VIRGINIA ELECTRIC AND POWER COMPANY
SURRY POWER STATION UNITS 1 AND 2
PLANT DESIGN INSPECTION INSPECTOR FOLLOW-UP ITEMS (IFIs)
REQUEST FOR ADDITIONAL INFORMATION

PLANT DESIGN INSPECTION INSPECTOR FOLLOW-UP ITEMS (IFIs)
SURRY POWER STATION UNITS 1 AND 2

RESPONSE TO REQUEST FOR ADDITIONAL INFORMATION

d) Motor time current curve:

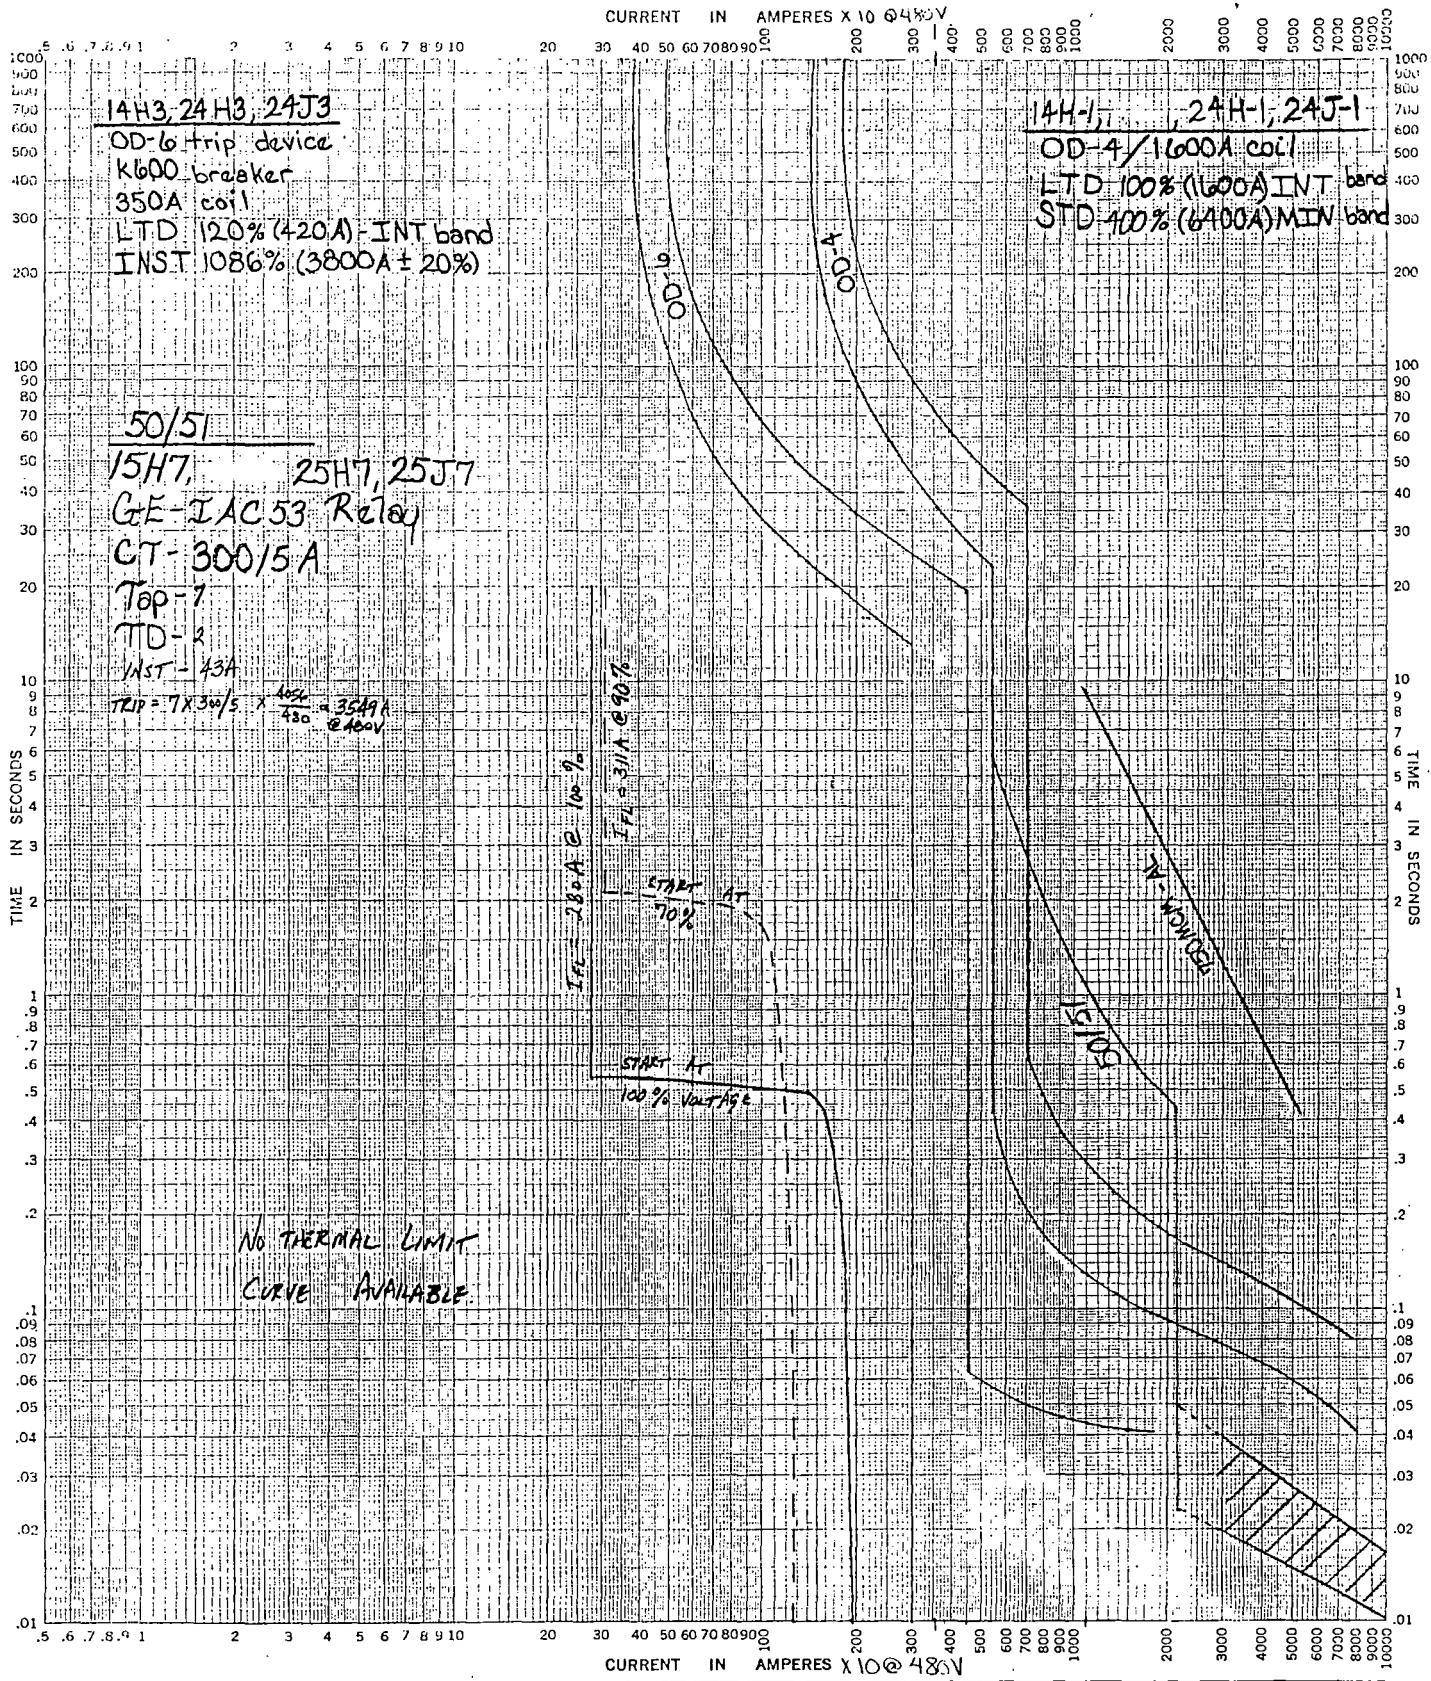
The motor will accelerate its original load (i.e., the Harris plant application) in less than 2 seconds at 75 percent voltage. However, the motor load at Surry is smaller than the originally intended load for the Harris plant application. No current curve exists for the specific Surry application.

SPS LowLoad Safety Injection Pump Motor Fuse Links In

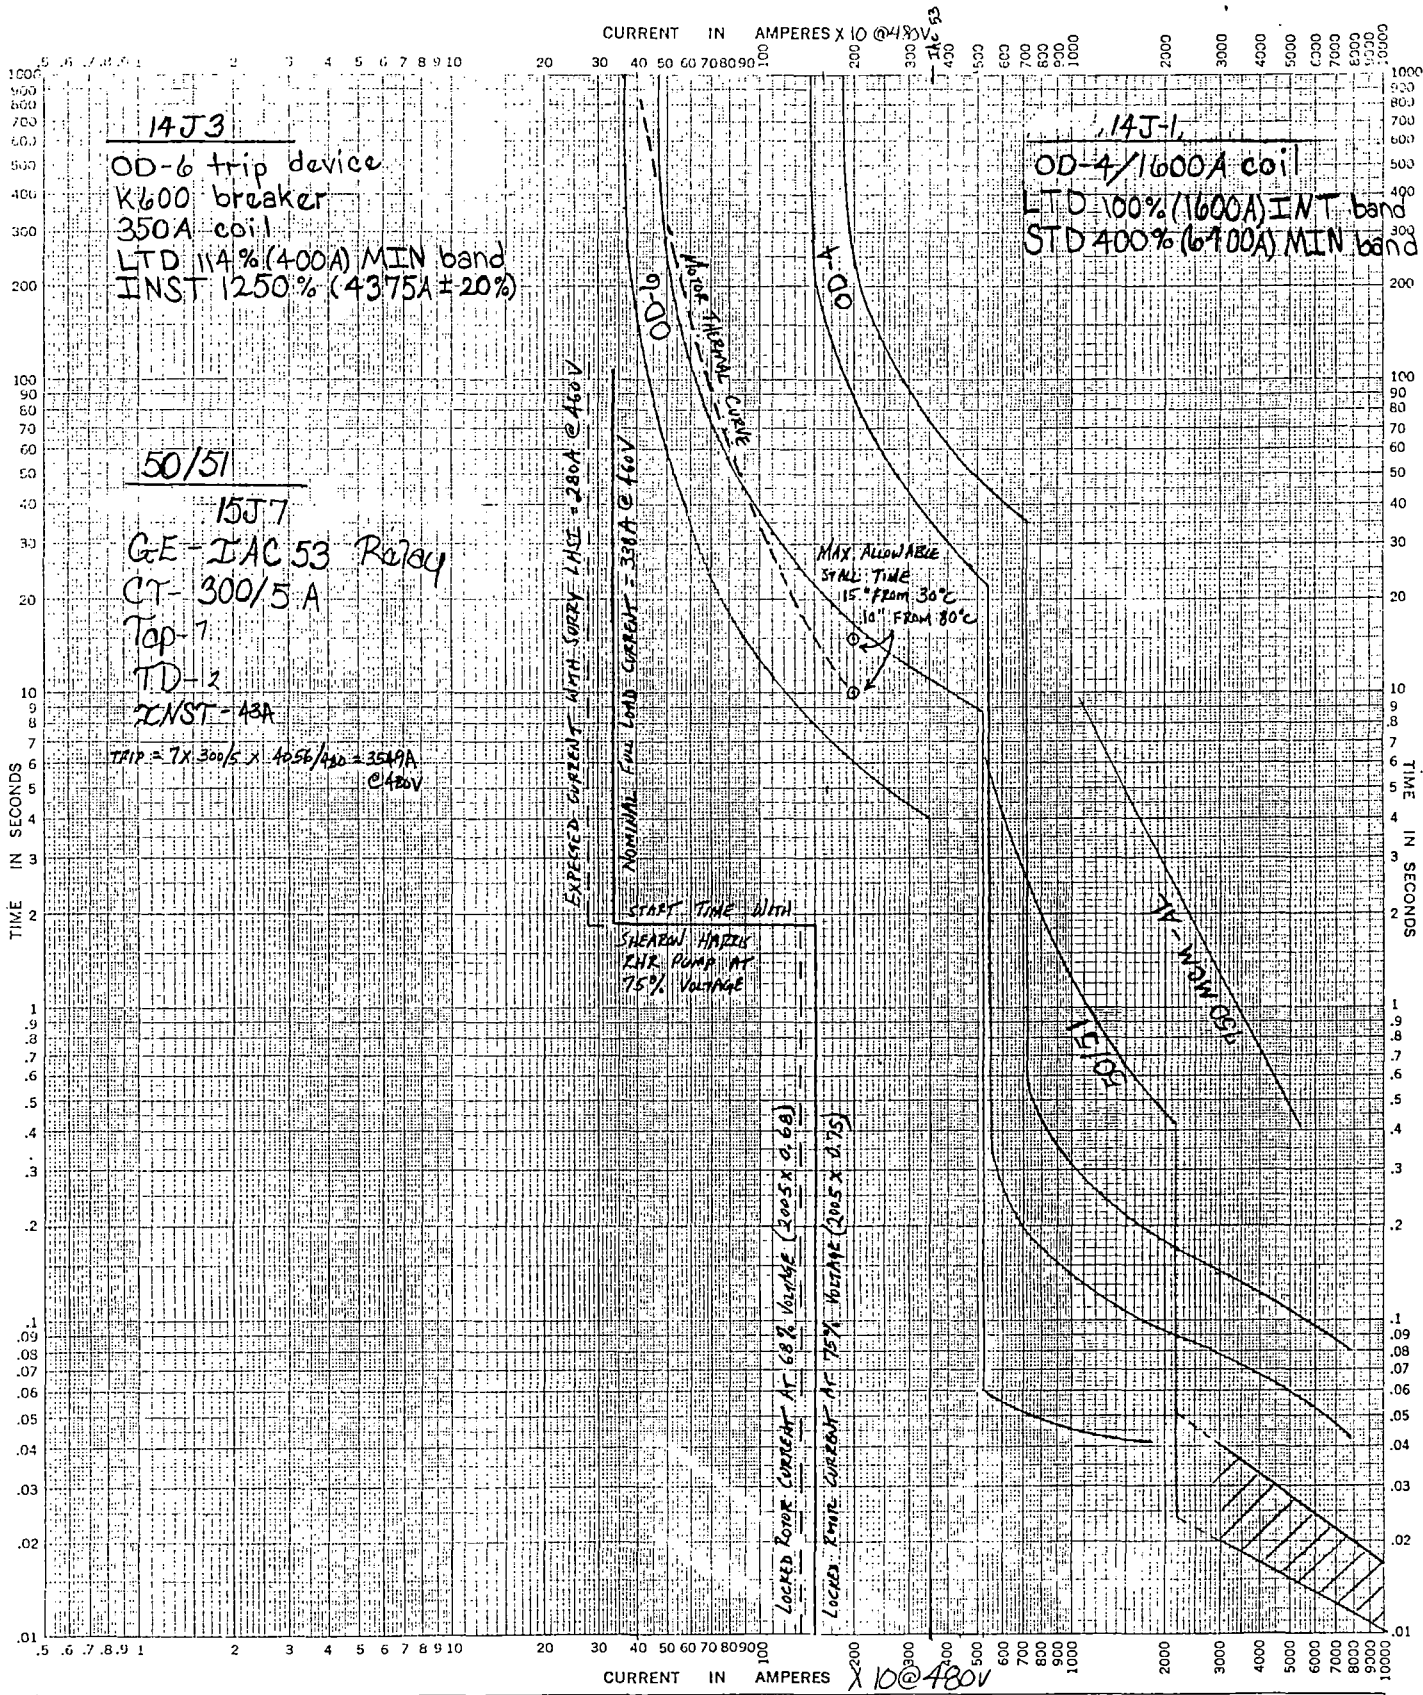
The available data for the 300 HP 1-SI-P-1B and the three 250 HP pumps are attached. The curves for the 300 HP motor show, based on the 80 degree Celsius thermal limit curve provided, that the circuit breaker does not protect the motor for the full range of current. However, this is acceptable in order to ensure that the motor is allowed to start. Based on the limitations of the protective device, if the protection is set faster, it might inhibit the start. No thermal limit curve is available for the other three motors.
